Arlington Conservation Commission

Agenda

Reference: Response to NOI Comments
Town of Arlington Hurd Field Renovation MassDEP File No 091-0337

**RE: Response to Comments from Wayne Chouinard, Town Engineer
Site Plan Review for Colonial Village Drive**

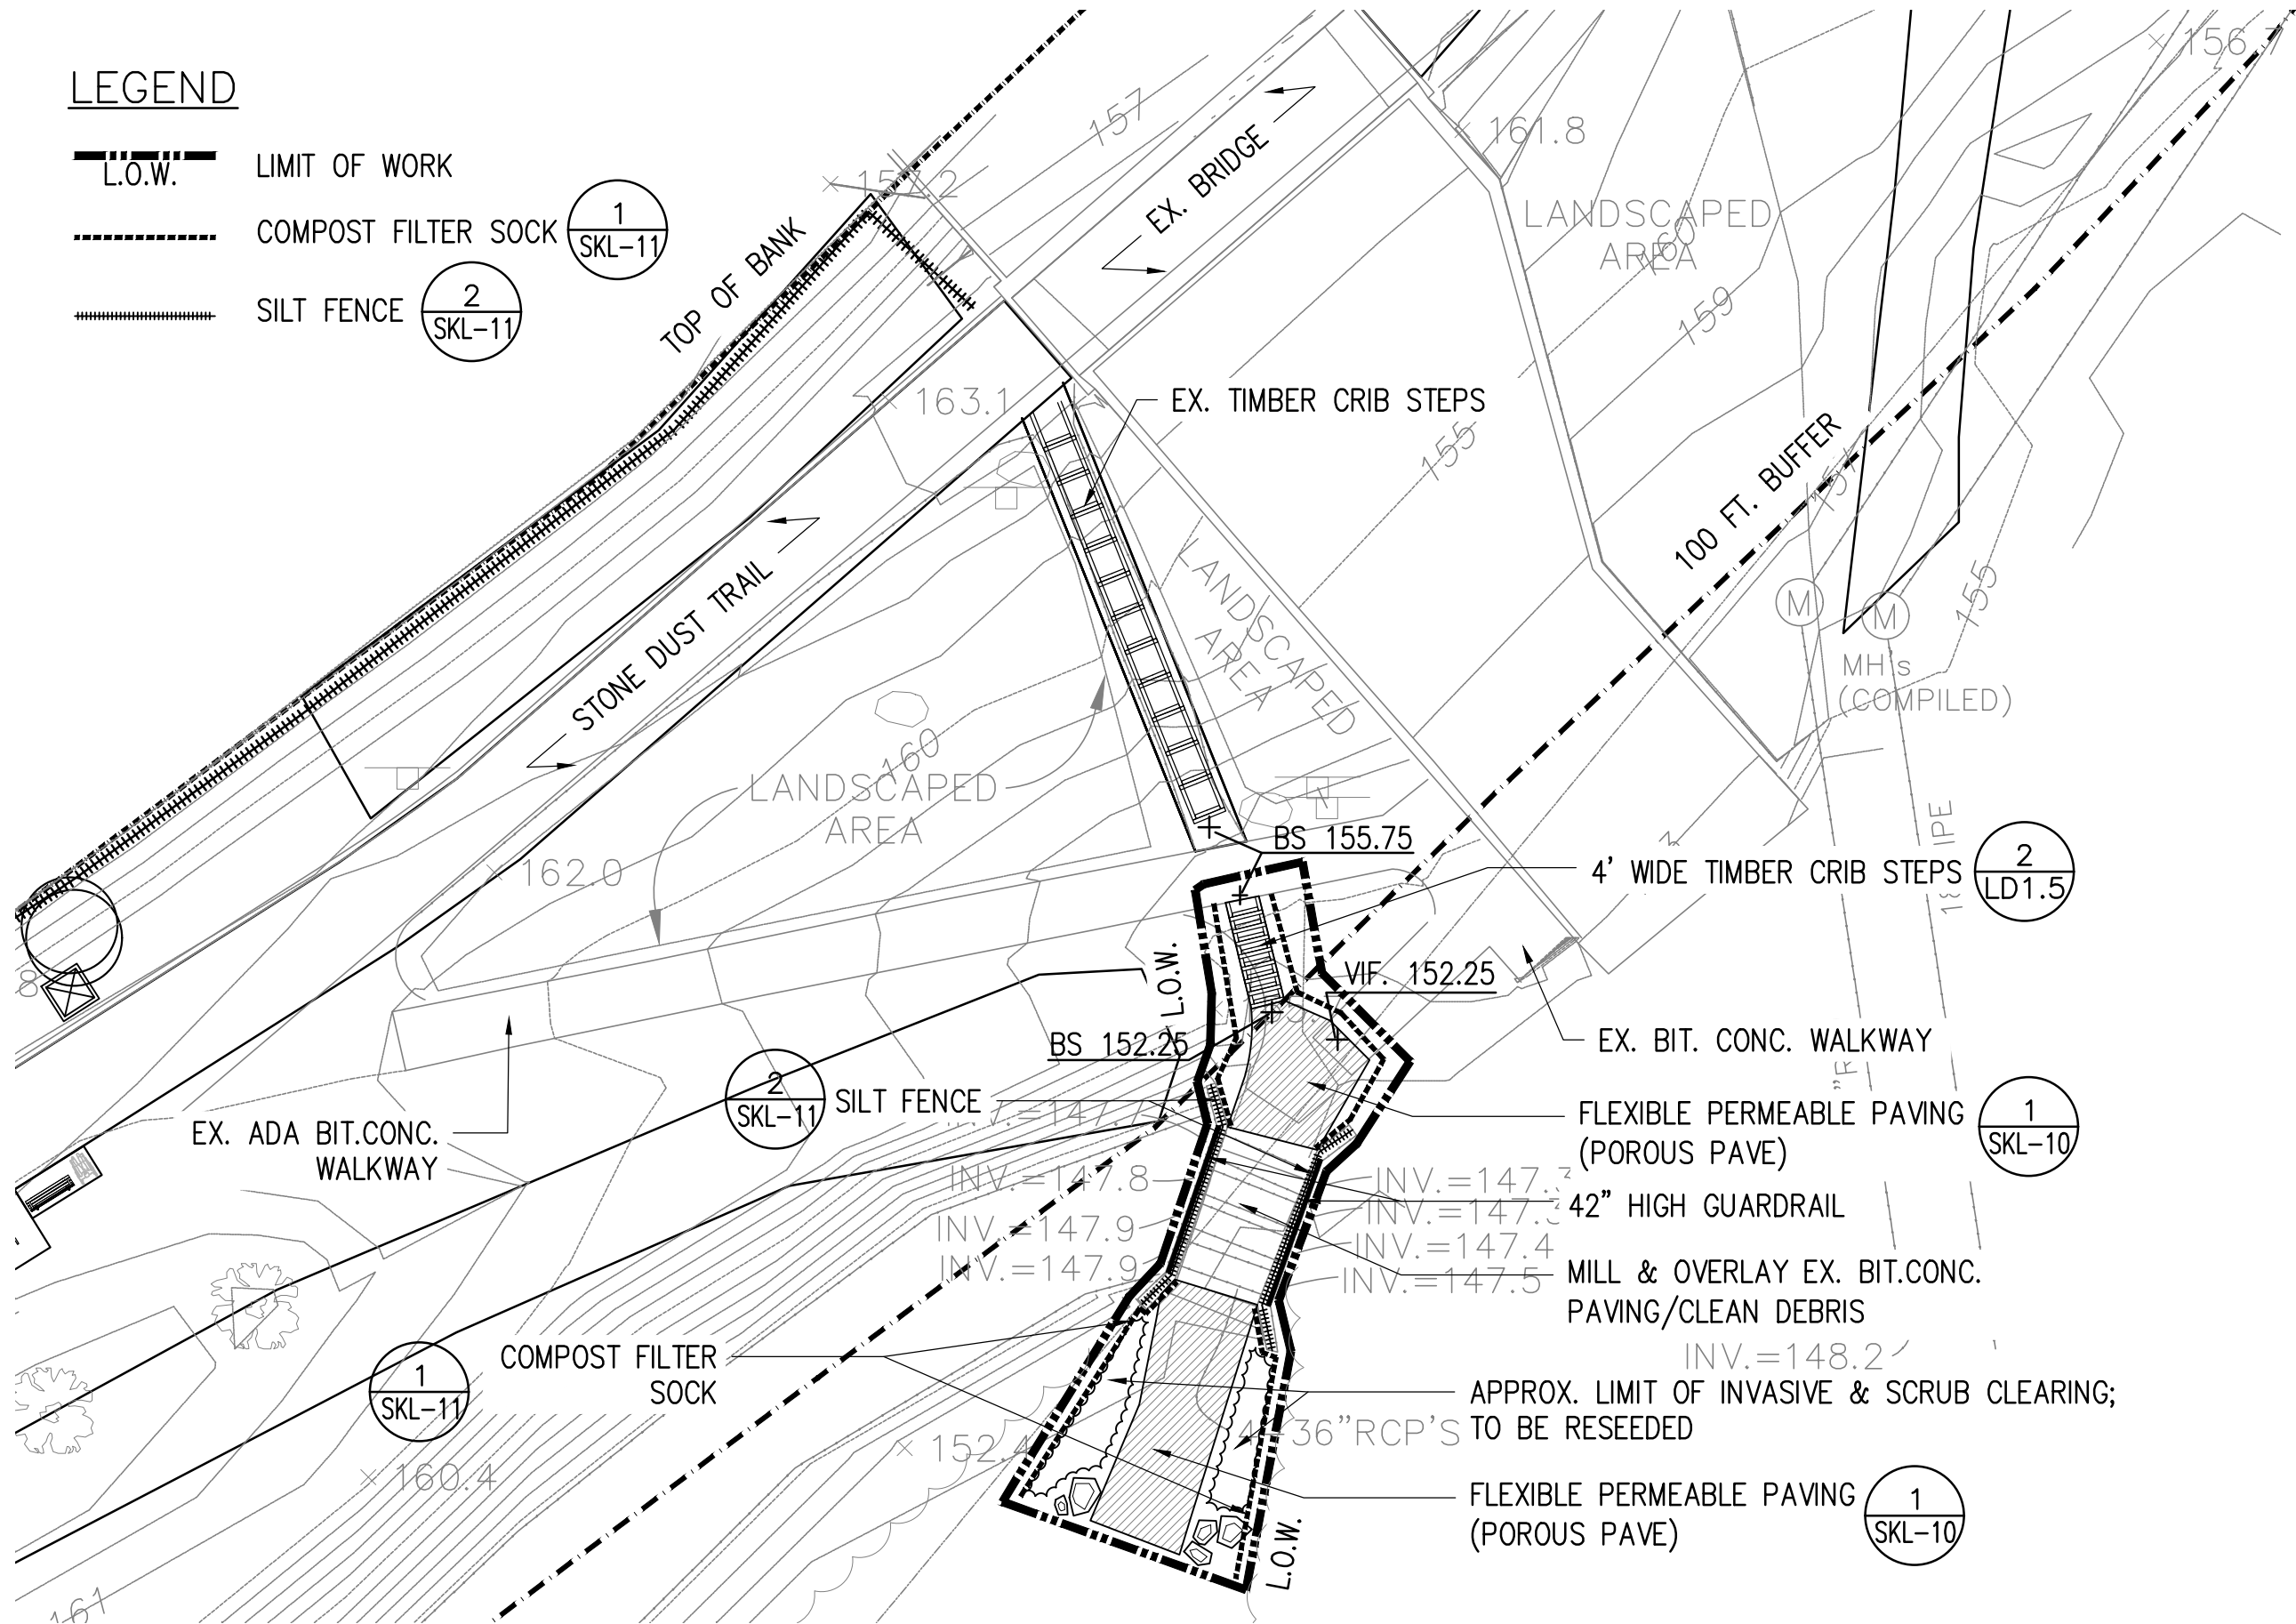
- a. Addressing the drainage issue at the area between the parking lot and Mill Brook by installing coir logs, backfill and planting/riprap. **This has been added, see attached rendered site plan.**

- b. Increase planting between Mill Brook and new path connecting to reservoir. **This has been added, see attached rendered site plan, pending FEMA approval in areas of Regulatory Floodway.**

- c. Addressing drainage issue at end of fence near bridge by installing coir logs, planting/rip rap. **This has been added, see attached rendered site plan.**

- d. Increase buffer in north part of site, between Mill Brook and the loop path by adding low plantings. **This has been added, see attached rendered site plan.**

- f. Add plantings in southeast corner of site to prevent cut through at fence. **This has been added, see attached rendered site plan.**
 - g. Any other porous options for overlook that might work? **The plaza is now permeable paving. See attached rendered site plan.**

- h. Narrow meadow mix on field side of path to make it run along path further. **This has been added, see attached rendered site plan.**
3. Look into reducing pavement, if possible, like making loop path be 5' wide instead of 6'. Can plaza space or connection from the bike path to the Reservoir be reduced?

- Loop path was reduced to 5' wide. Plaza space at the entrance is now proposed as permeable paving. The connection from bike path to the Reservoir, however, will remain the same width to safely allow enough passing room for two way pedestrian/bike traffic. Please see attached rendered site plan.**
